**FEBRUARY 27<sup>TH</sup>, 2020 – PLANNING BOARD HOTEL  
APPLICATION CONTINUED**

**20 Central Street, Rockport, Maine  
Site Plan Review  
Revised Documents**

**RE: Site Plan Review Application Revisions  
Rockport Harbor Hotel  
20 Central Street, Rockport**

Subject: **Site Plan Review, Revised Written Statement  
Rockport Harbor Hotel**

REV NEW	
SHEET TITLE	FRONT EXTERIOR LIGHTING PLAN
PROJECT	ROCKFORD OR HOTEL
LOCATION	CENTRO AT STREET
DATE	
Bay View Management, LLC

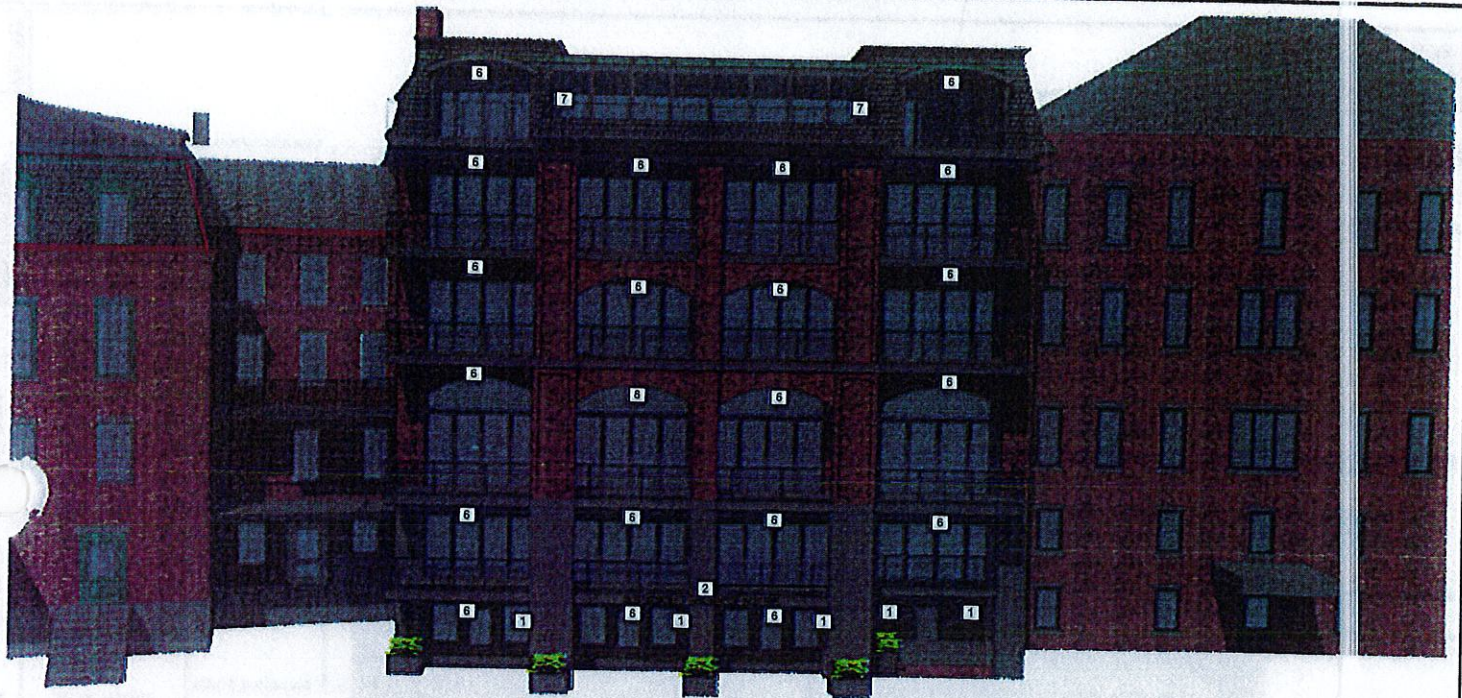
The backside of the building is now six stories as viewed from behind rather than the seven stories as shown on previously submitted plans. There are two stories located below Central Street. The number of overall fixtures has been reduced by about twenty five percent. Most rooms have an accent light on the exterior walls with a timer that goes off at 10 or 11 PM. John Viehman clarified that they are low wattage and primarily for accents. The fixture on the deck above each door provides primary lighting.

Mr. Laurent wanted clarification as to the height of the new fixtures located on the gables and challenged that any lighting fixtures that are not street lights are prohibited above 25 feet, which would put the applicant's lighting plans in nonconformance of the ordinance. He referenced Section 800, page 8-3, 801.7.4- C, Lighting Standards of Rockport's Land Use Ordinance. The Board asked the applicant if the project could continue with the removal of these fixtures. Mr. Smith stated that it would be a hardship, and no exterior lighting on exits could pose a hazard/safety code issue. There was ensuing discussion among the board as to the context of the surrounding paragraphs. The ordinance intent was clarified to be applicable to freestanding light fixtures.

**FINDING** Clark Doran moved as a finding of fact that the lighting plan complies with Section 801.7 of Rockport's Land Use Ordinance. John Viehman seconded. No further discussion.

SHEET TITLE:  
BACK EXTERIOR  
LIGHTING PLAN

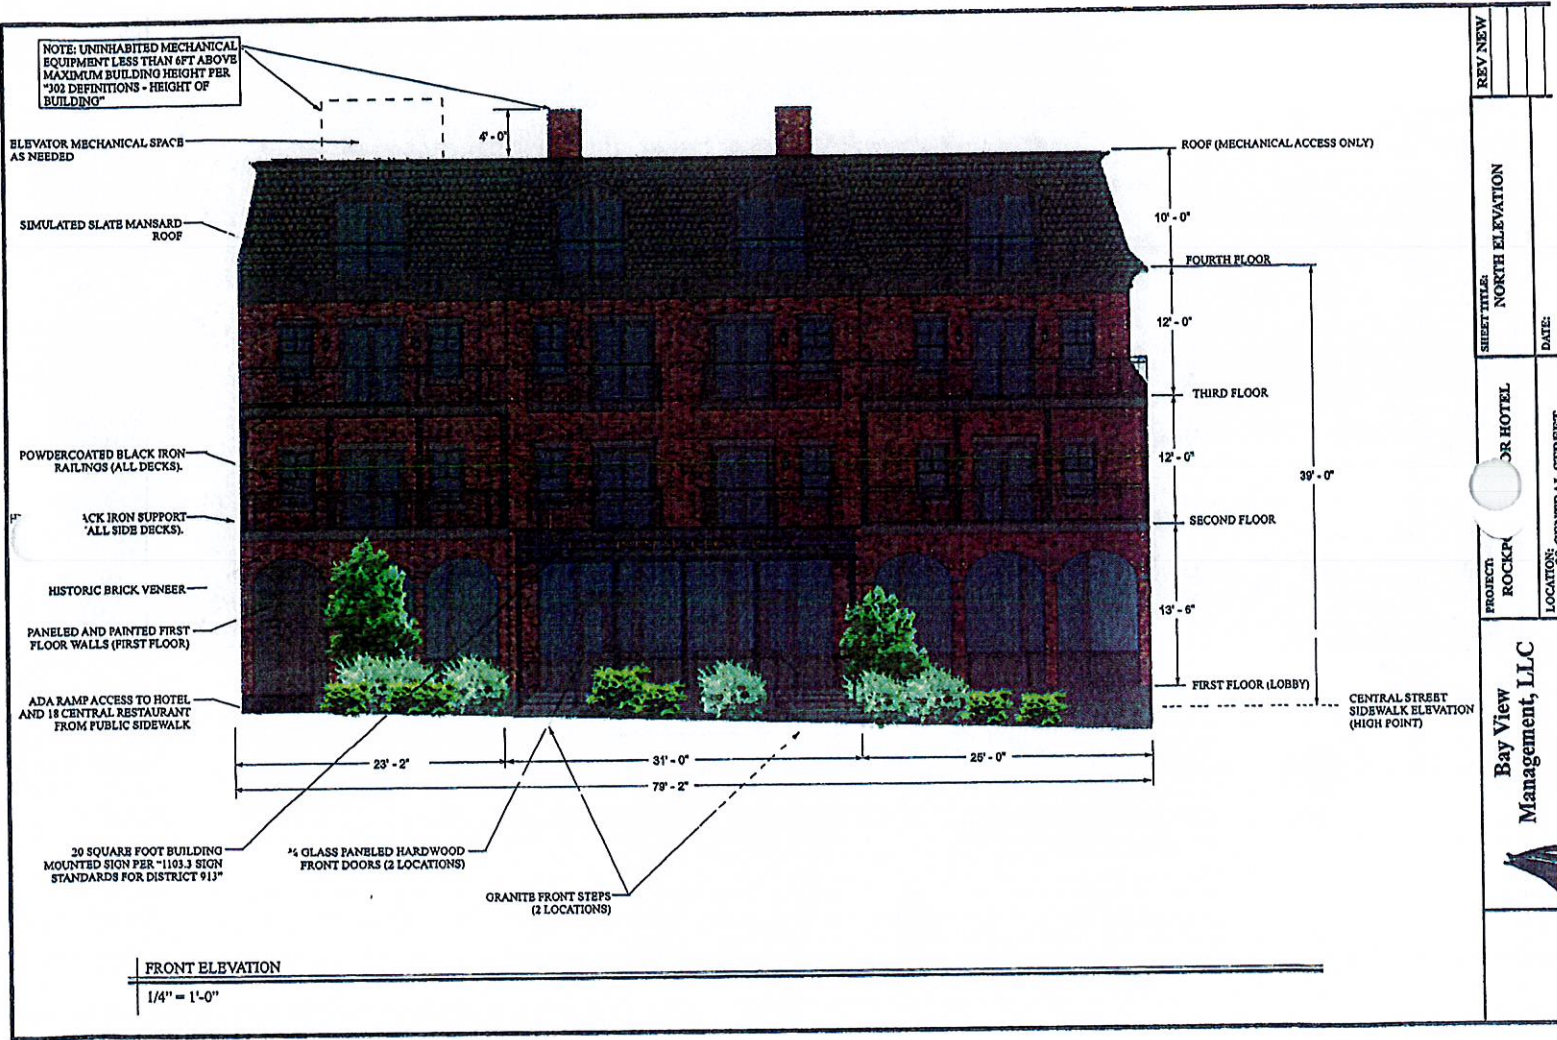
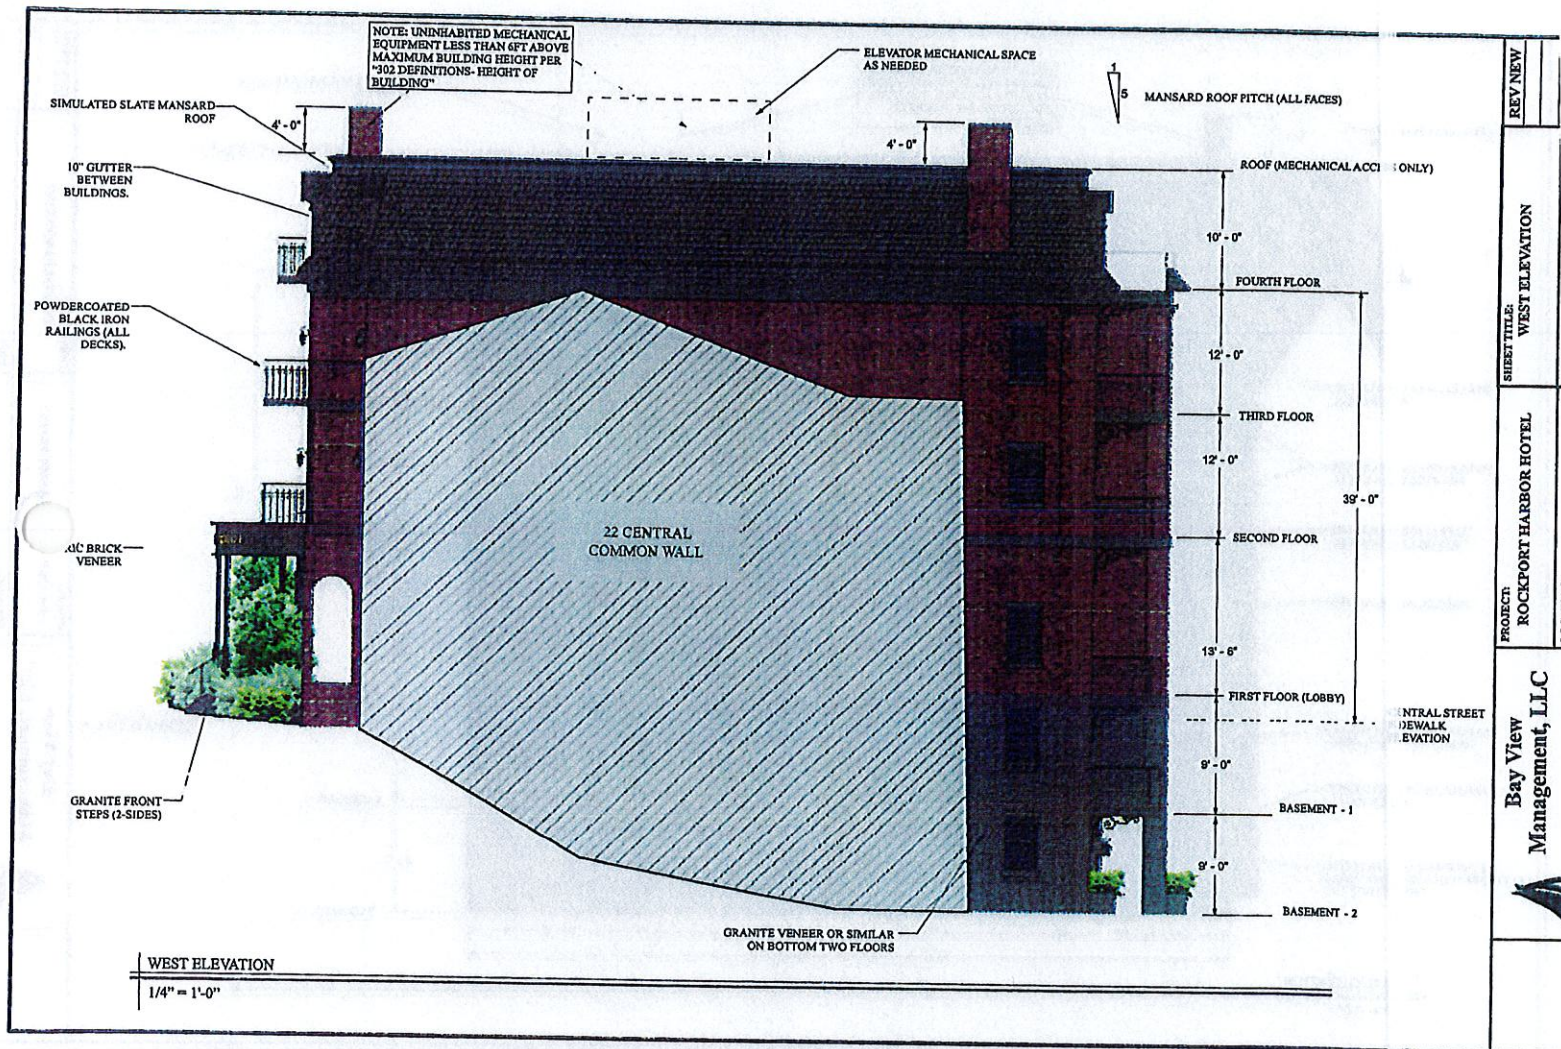
The backside lighting plan was shown and the applicant clarified that the wall mounted fixtures are there more for aesthetics than for safety and are timed to go off at 11 PM at night but can be overridden by guests using a control inside of the hotel room. The Central Street elevation was shown to the Board, and some of the architectural details were discussed. The curved rails originally proposed are now straight because of public input.
